HISTORIC AND DESIGN REVIEW COMMISSION

February 06, 2019

HDRC CASE NO: 2019-033
ADDRESS: 107 LOVERA BLVD
LEGAL DESCRIPTION: NCB 9003 BLK 15 LOT 36 & 37
ZONING: R-4, H
CITY COUNCIL DIST.: 1
DISTRICT: Olmos Park Terrace Historic District
APPLICANT: Ginger and Ross Hebert
OWNER: Ginger and Ross Hebert
TYPE OF WORK: Landscape modifications
APPLICATION RECEIVED: January 21, 2019
60-DAY REVIEW: March 20, 2019

The applicant is requesting a Certificate of Appropriateness for approval to perform front yard landscape modifications including the replacement of natural lawn with rock beds, limestone slab pavers, and a variety of plantings.

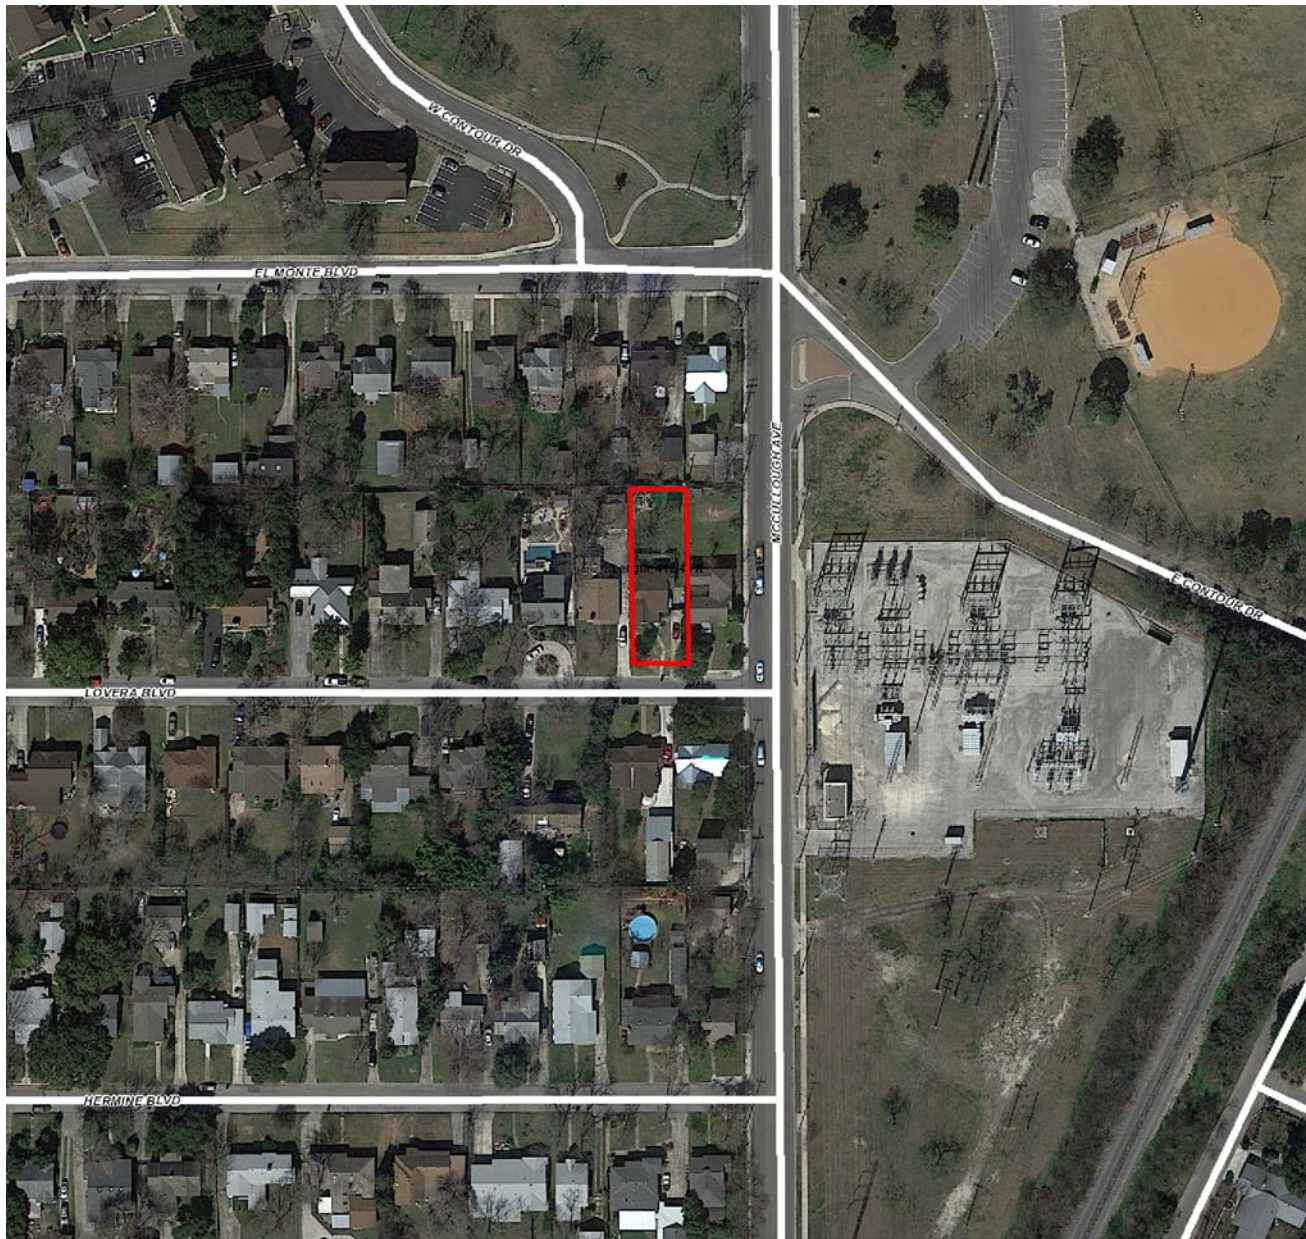
- c. NATURAL LAWN – The applicant is requesting to remove all of the existing, natural lawn turf and install a design consisting of rock beds and a variety of plantings. Per the Historic Design Guidelines for Site Elements 3.A.ii, historic lawn areas should never be reduced by more than 50% and removal of lawn areas should be limited to along fences, walkways, and drives. Staff finds that that the removal of natural lawn must be mitigated by the restoration of natural lawn and the installation of low-ground cover and other xeric plants and that at least 50% of the lawn area remains as plantings instead of hardscaping. The proposed plant includes the following plants:

- v. Existing Sago Palm
 - vi. Existing Mountain Laurel
 - vii. Existing Oak Tree
- d. HARDSCAPE – The applicant has proposed to install a variety of hardscaping elements including (1) rock beds with shadow stone and/or shimmer bay rocks, (2) 40” by 26” limestone slab pavers, and (3), a Keylime quartz boulder. Per the Guidelines for Site Elements 3.B, large pavers, asphalt, or other impervious surfaces should not be installed where they were not historically located, new pervious hardscapes should be limited to areas that are not highly visible, and rock mulch should not be used as wholesale replacement for lawn area. Staff finds that proposed installation of hardscaping is mitigated by the installation of plantings. However, staff finds the design should exclude the limestone pavers and the keylime quartz boulder or relocate them to the rear yard.

Staff recommends approval of the front yard modifications based on findings c through d with the following stipulations:

- i. That natural lawn, low-ground cover, or other xeric plants be reintroduced to the design to cover at least 50% of the total front yard area. This may be accomplished by substituting either portion 1: Shadow Stone or 2: Shimmer Bay Rock with natural grass per the submitted site plan. The applicant may also refer to UDC Appendix E: San Antonio Recommended Plant List.
- ii. That the limestone pavers and Keylime quartz boulder is removed from the front yard or relocated to the rear yard.
